**Evaluation of proposed move for Water Right No. 35902 & 42771**

Proposed: Move water right no. 35902 & 42771 a distance of 2,644 ft to the south onto a new location.

WELL TEST ANALYSIS

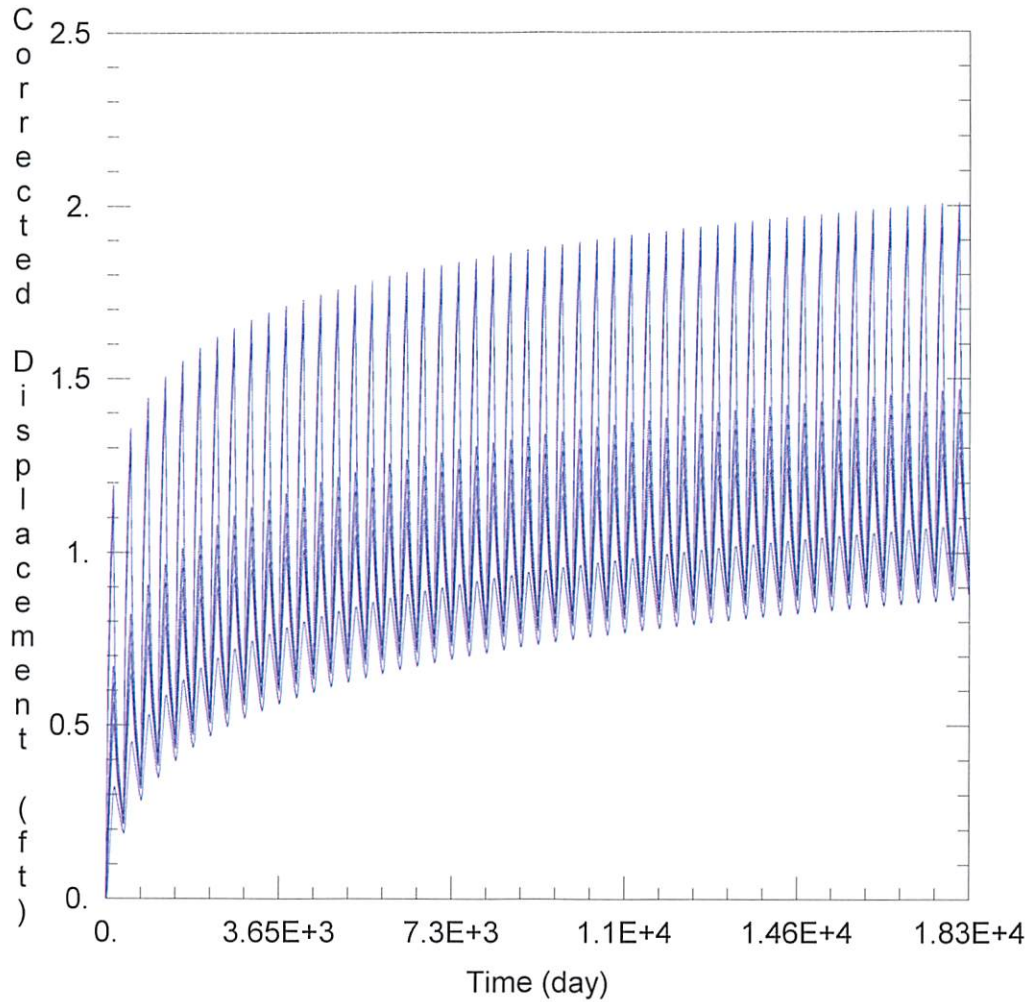
Net drawdown does not exceed the drawdown allowance of 4.0 ft for any well within 1 mile of the proposed location. Therefore, critical well analysis is not necessary.

The proposed move is likely to create minimal effects on neighboring wells and appears unlikely to cause impairment. Any concerned neighbors should contact GMD3 at (620) 275-7147 or the Division of Water Resources at (620) 276-2901.
